Architect's Supplemental Instructions

Architect's ASI No: 024

Project:
Webster University
Interdisciplinary Science
Building

Description: ASI – 024 (RFI-222, 233, 235 & 236)

1 COMBINATION FIRE / DOMESTIC BUILDING WATER SERVICE
P0403 SCALE: N.T.S.

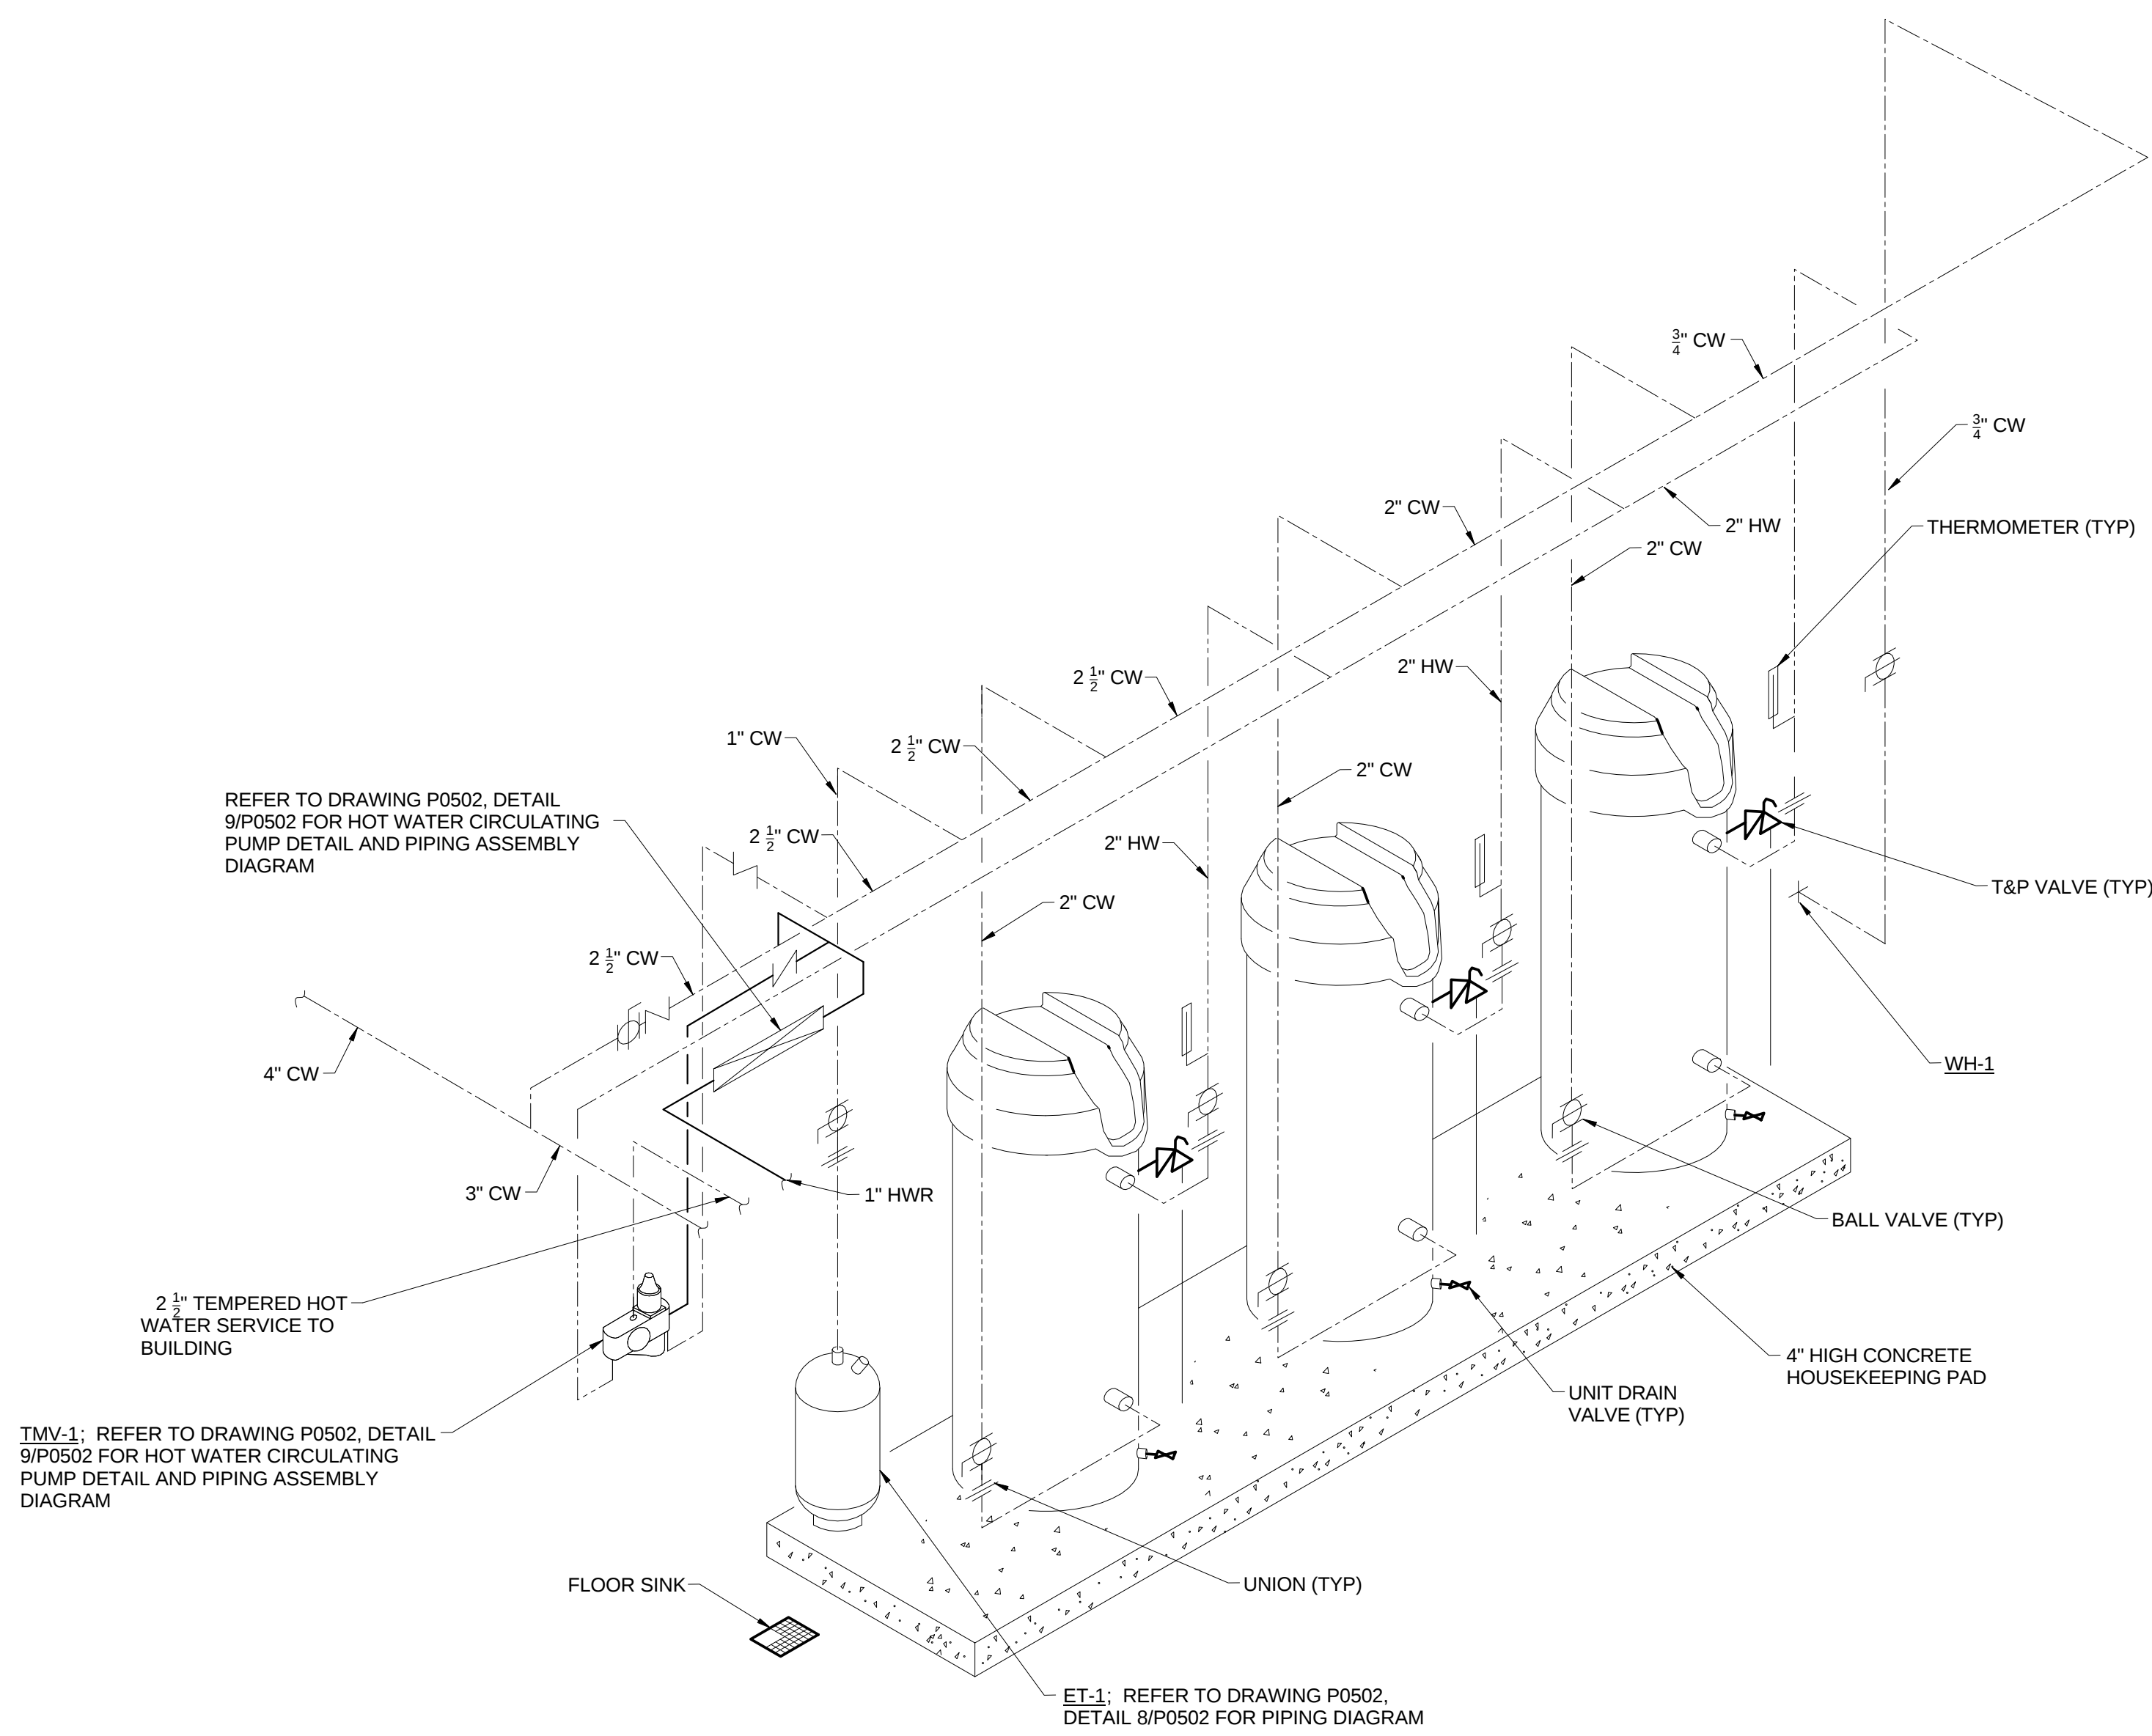
RFI-235, (P0101.A & P0403); Revise 8-inch combination fire and domestic water service as noted. Remove 8-inch building service valve as indicated. Install new 4-inch domestic valve on 4-inch domestic service line as shown on drawings P0101.A and riser diagram sheet P0403. Relocate pressure gauge as indicated on plans.
